REGULATION No. 46
(Devices for indirect vision)

Proposal for draft amendments to Regulation No. 46

Submitted by the informal group on Camera-Monitor Systems */

Figure 4: **Class I field** Field of vision of ~~Class I mirror~~

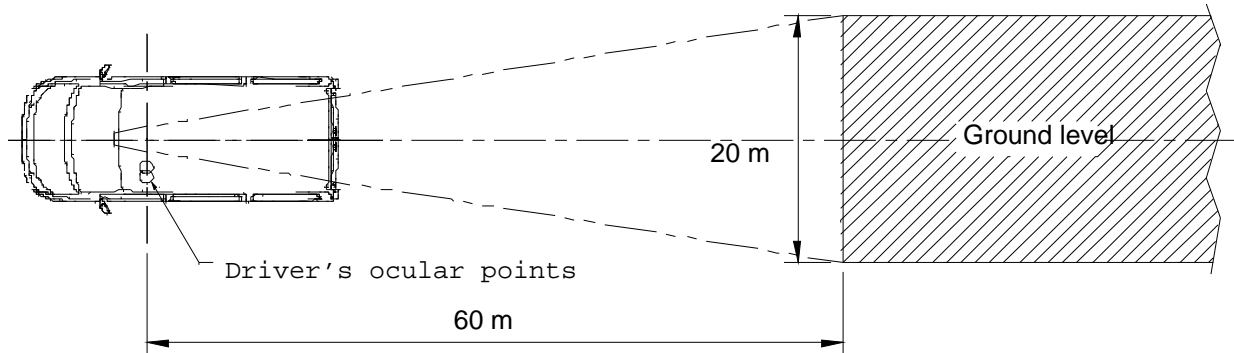
Replace “Interior rear-view mirror” with “Central rear-view field of vision”

Replace “Figure 3: Field of vision of Class I mirror” with “Figure 3: Class I field of vision”

- 15.2.4.1. ~~Interior rear-view mirror~~ **Central rear-view field of vision** (Class I)
The field of vision must be such that the driver can see at least a 20 m wide, flat, horizontal portion of the road centred on the vertical longitudinal median plane of the vehicle and extending from 60 m behind the driver's ocular points (Figure 4) to the horizon.

Figure 5: Field of vision of Class II mirrors Class II field of vision

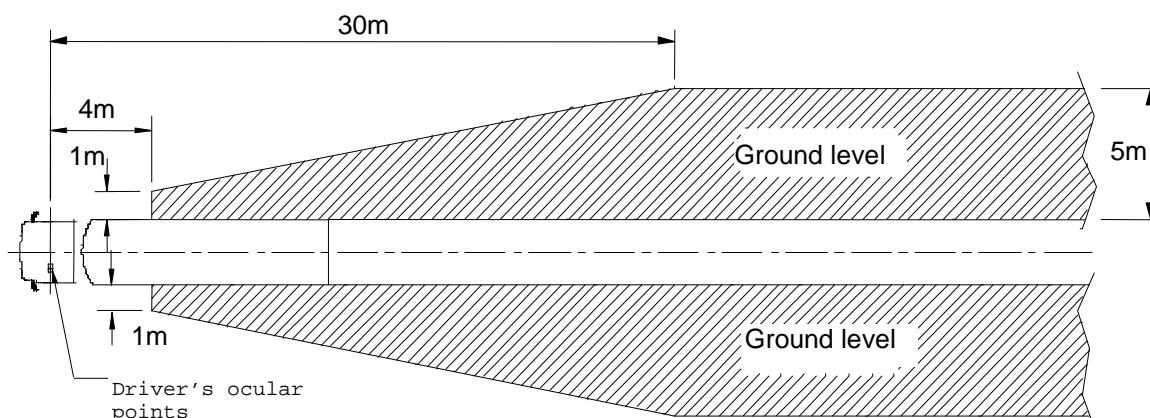
Replace "Exterior" with "Main"

Replace "mirror" with "field of view"

Replace "Figure 4: Field of vision of Class II mirrors" with "Figure 4: Class II field of vision"

Suggestion for IGCMS: as proposed by Brigade because it is in line with 2.1.4..

Figure 6: ~~Field of vision of Class III mirrors~~ **field of vision mirrors**

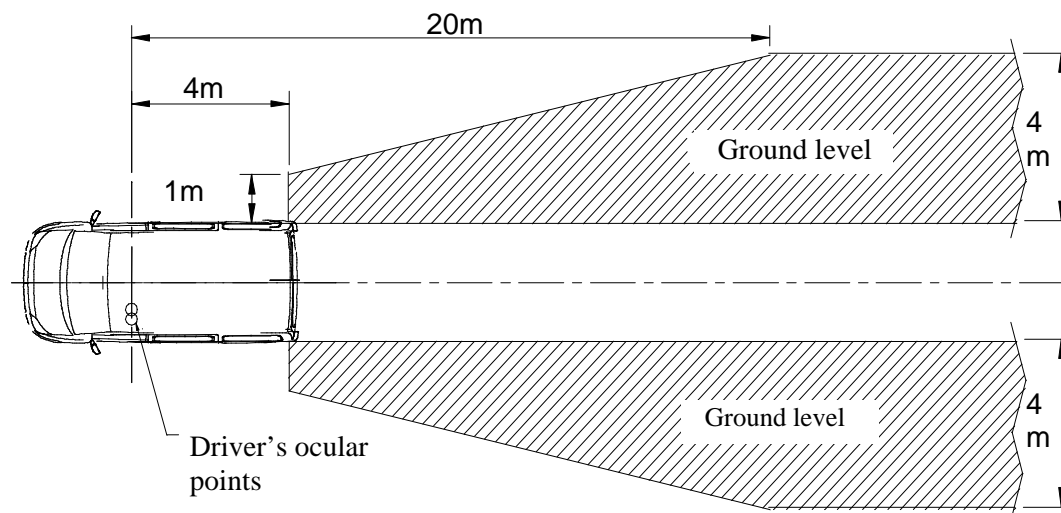
Replace "Exterior" with "Main"

Replace "mirror" with "field of view"

Replace "Figure 5: Field of vision of Class III mirrors" with "Figure 5: Class III field of vision"

~~Figure 7: Field of vision of Class IV wide-angle mirrors~~ **Class IV wide-angle field of vision**
 Suggestion for IGCMS: as proposed by Brigade because it is in line with 2.1.4..

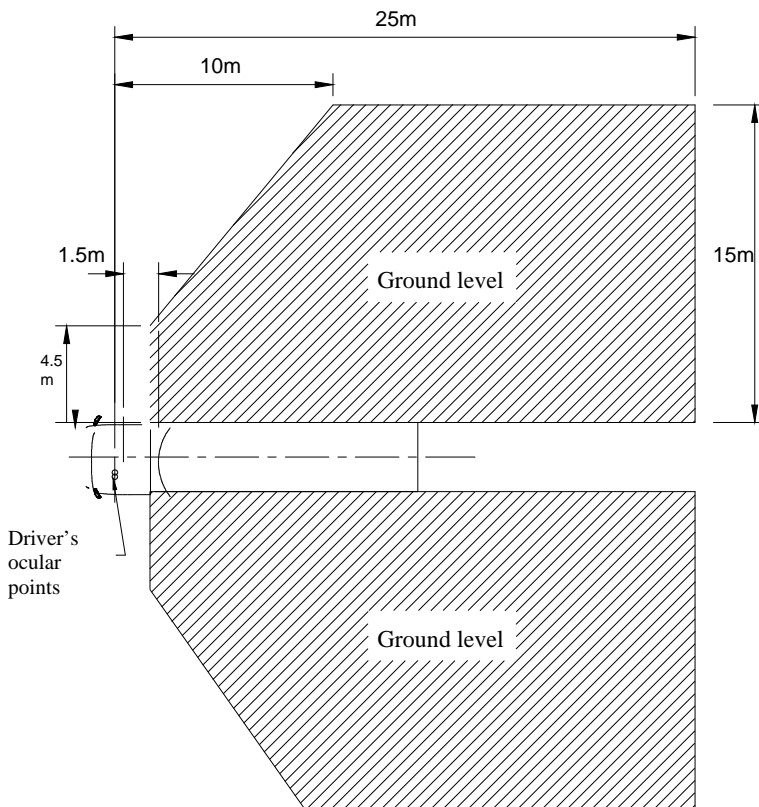
Replace “Figure 6: Field of vision of Class IV wide-angle mirrors” with “Figure 6: Class IV wide-angle field of vision”

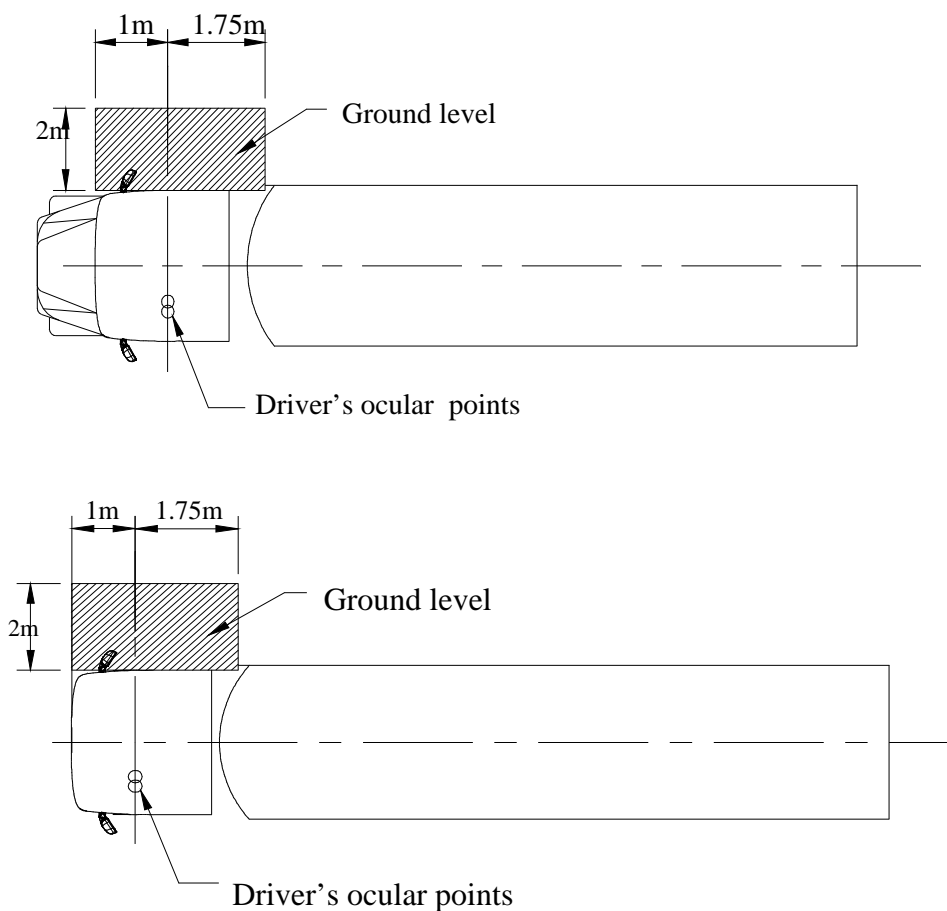
Replace "Figures 7a and 7b: Field of vision of Class V close-proximity mirror" with "Figures 7a and 7b: Class V close-proximity field of vision"

~~Figure 9: Field of vision of Class VI front mirror~~ **Class VI front view field of vision**

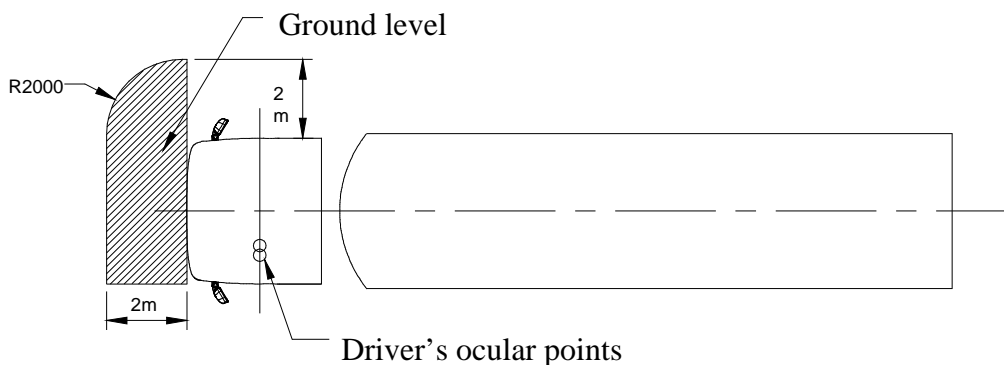
Replace “Figure 8: Field of vision of Class VI front mirror” with “Figure 8: Class VI front view field of vision”

Figure 10: Field of vision of Class VII field of vision mirrors.

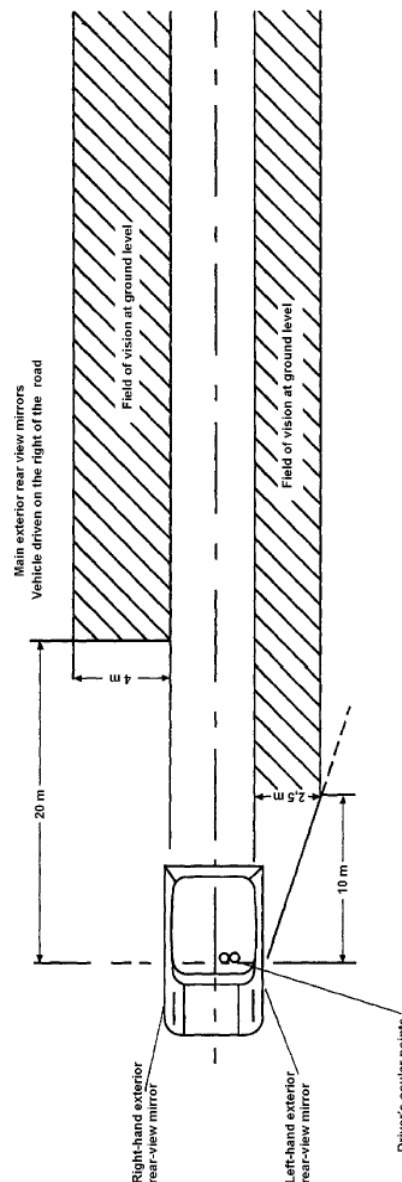
15.2.4.7.2. ~~Exterior~~ **Main rear-view field of vision mirror** on the passenger's side

Suggestion for IGCMS: as proposed by RDW
